# SARATOGA ASSOCIATES

December 19, 2017

Re: Visual Resource Assessment  
Proposed Wireless Telecommunications Facility  
15 Rockledge Road  
Nelsonville, NY

Figure B1

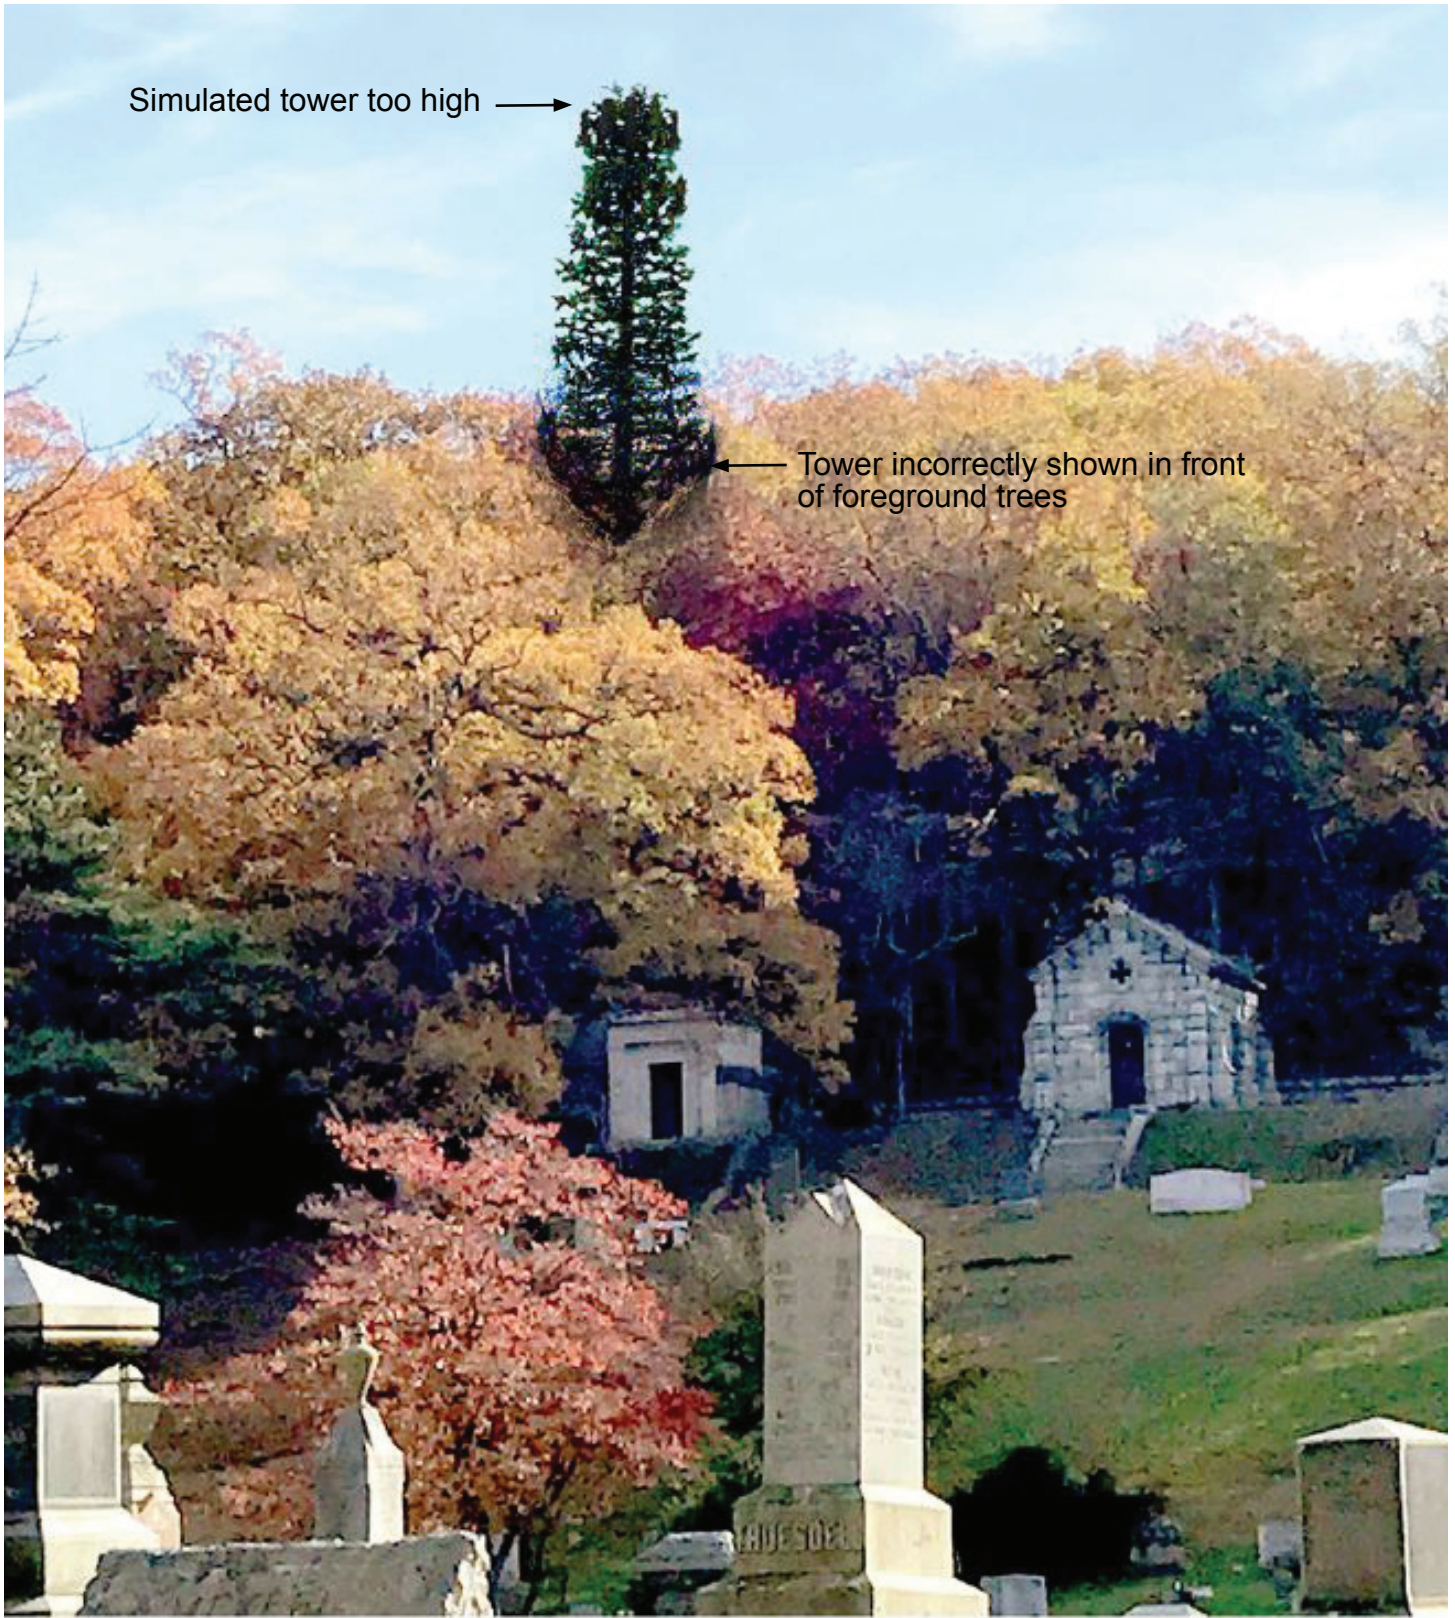
Comment 5: Actual photo of balloon test (At a Glance, p .9).

Balloon flown at 120ft above grade →  
at the request of Town Engineer.  
(10 feet higher than proposed tower)

Response 5: The photo provided appears to have been taken during the November 4, 2017 balloon test. In the “At a Glance” document this color photo is artificially desaturated to a black and white image with the notable exception of the red balloon - which remains in full color. This photo manipulation devalues the visual prominence of the foreground landscape to deliberately draw attention to the balloon.

Figure B2

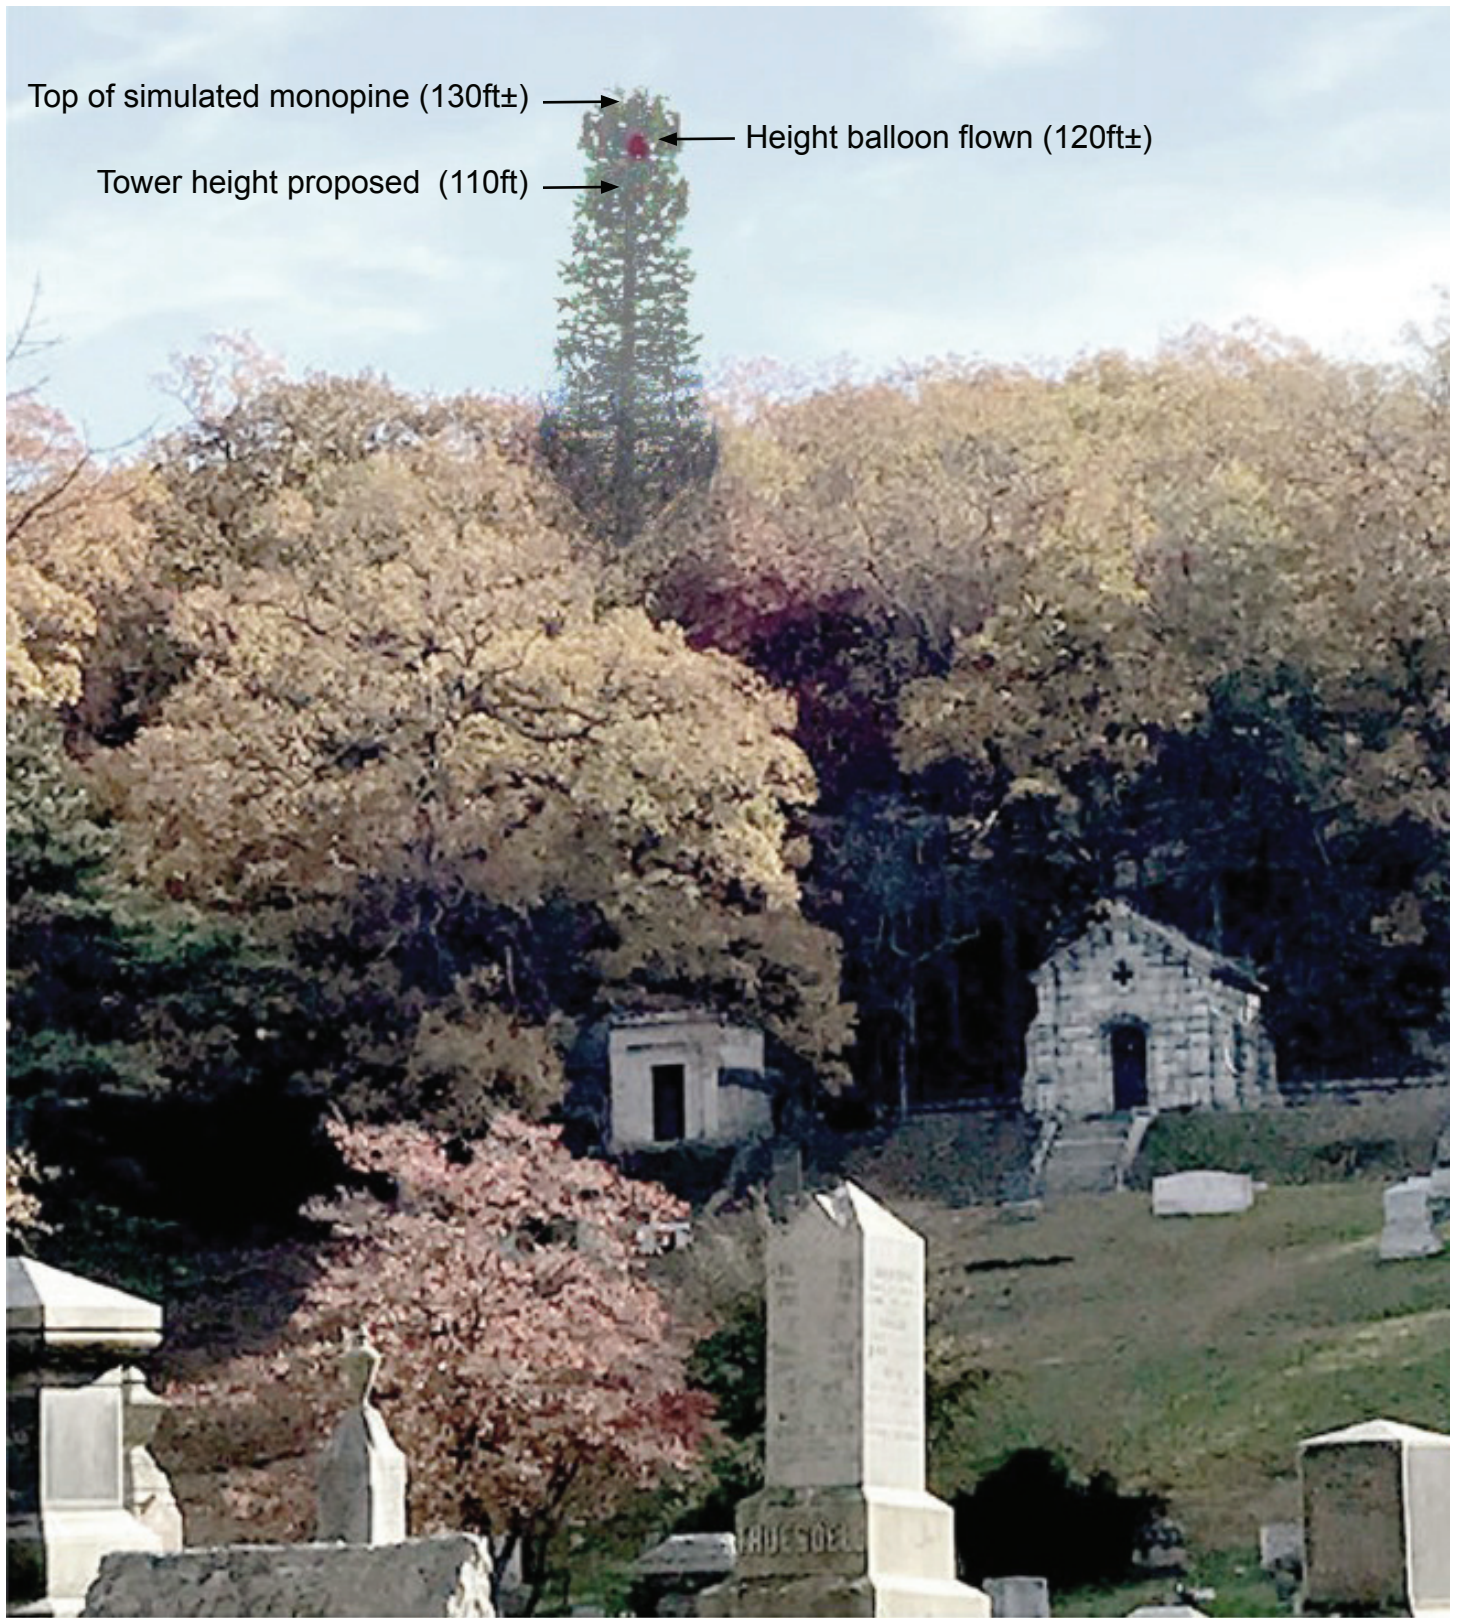
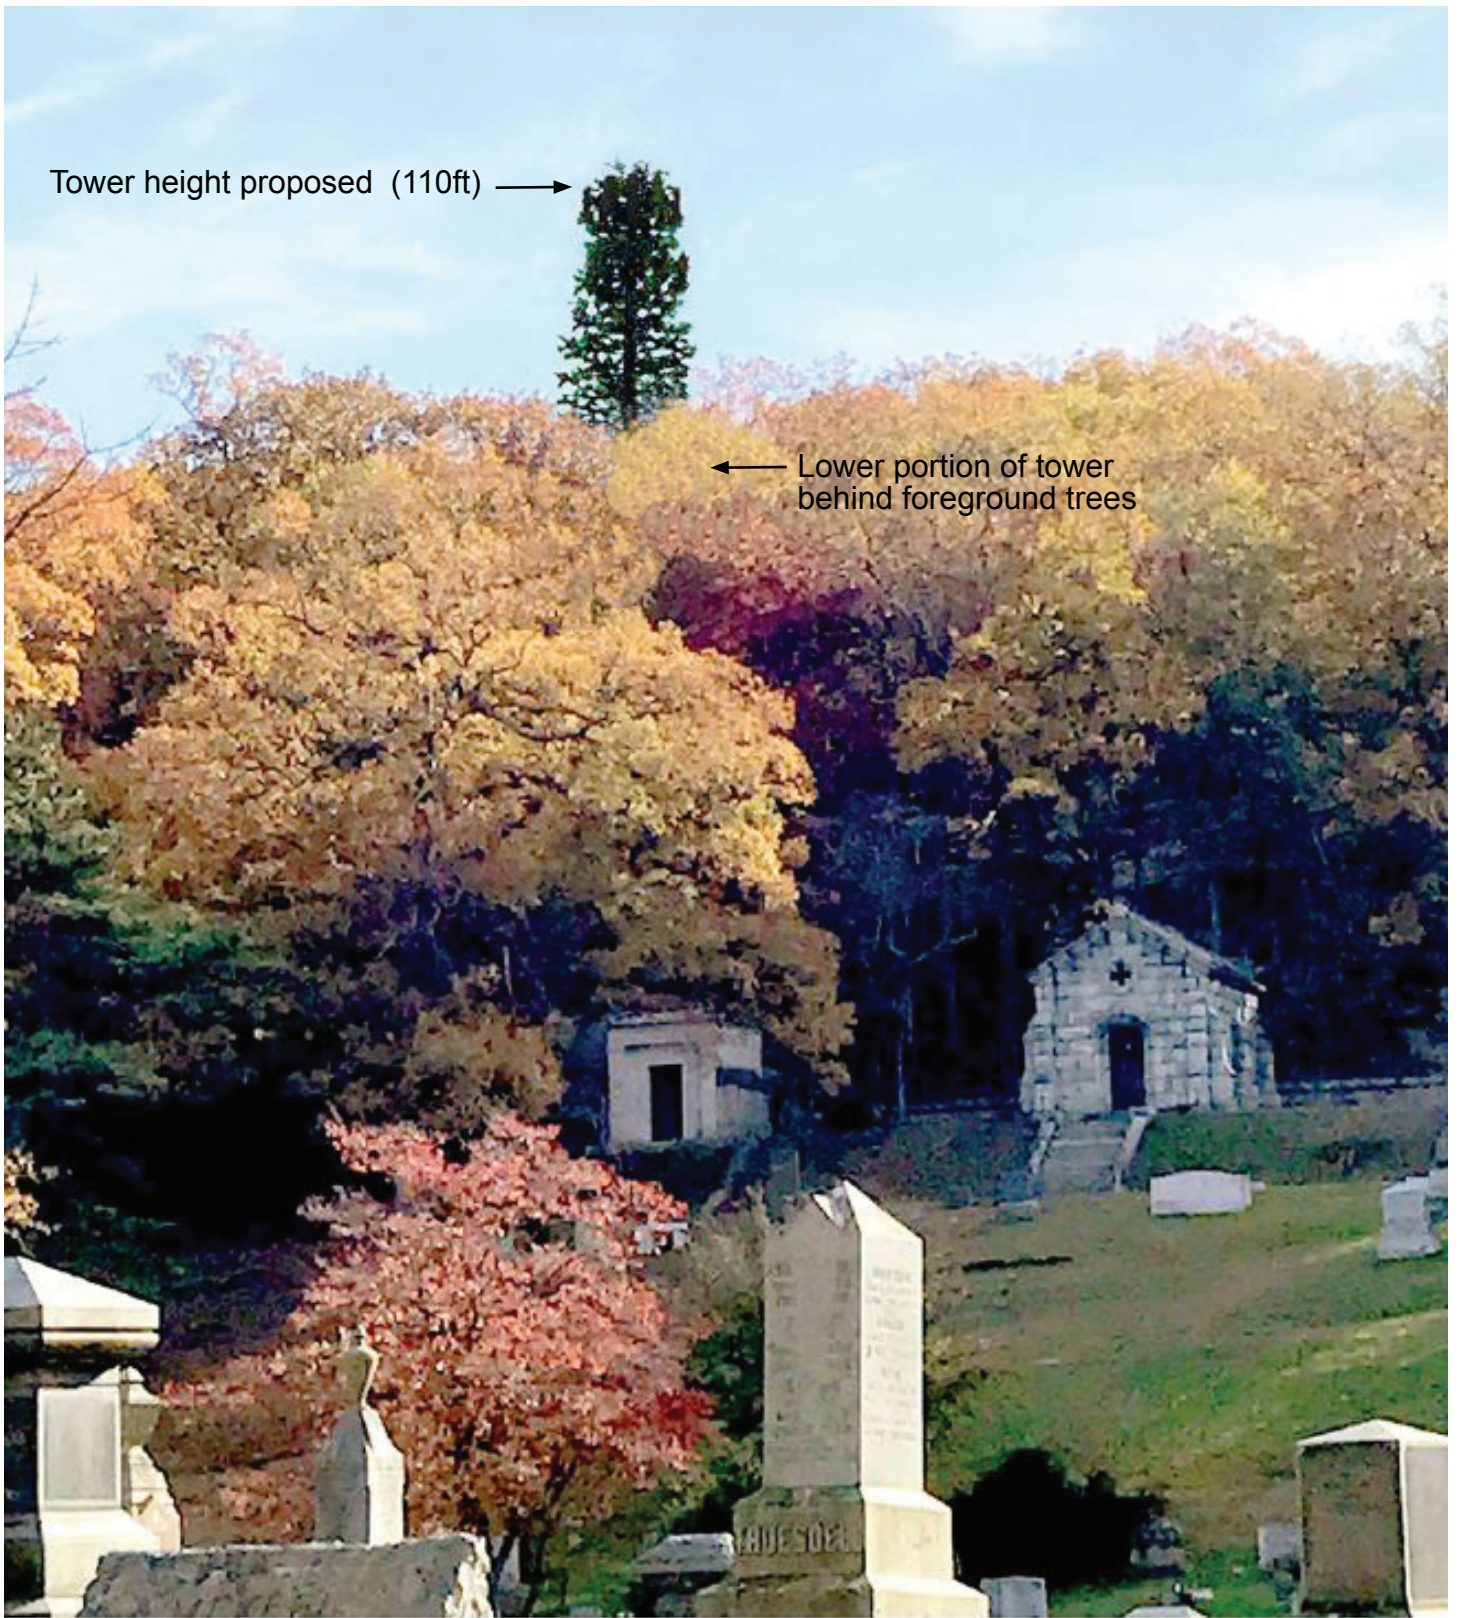
Comment 6: Photo simulation of proposed tower installation of the balloon test (At a Glance, p. 9).

Response 6: During the November 4, 2017 balloon test the balloon was intentionally flown approximately 10 feet higher than the proposed tower at the request of Town Engineer, Ron Gainer. The photo simulation provided in the “At a Glance” document appears to be based on the height of the balloon as flown. Consequently the photo simulation depicts the tower as being substantially taller than the proposed design. The photo simulation also shows the monopine tower in front of foreground vegetation. The trees in front of the proposed tower appear to be on Cold Spring Cemetery property or are otherwise part of the forest buffer to remain. This photo simulation significantly overstates the degree of tower visibility as viewed from the Cold Spring Cemetery. Accordingly, the photo simulation provided is not an accurate representation of the proposed facility.

To demonstrate the inaccuracy of the PCS simulation Saratoga Associates has prepared a corrected version of this image. The corrected photo simulation is attached as Appendix B. In addition please refer to Figure 5b in the June 2, 2017 VRA for an accurate leaf-off season representation of project visibility from this location.
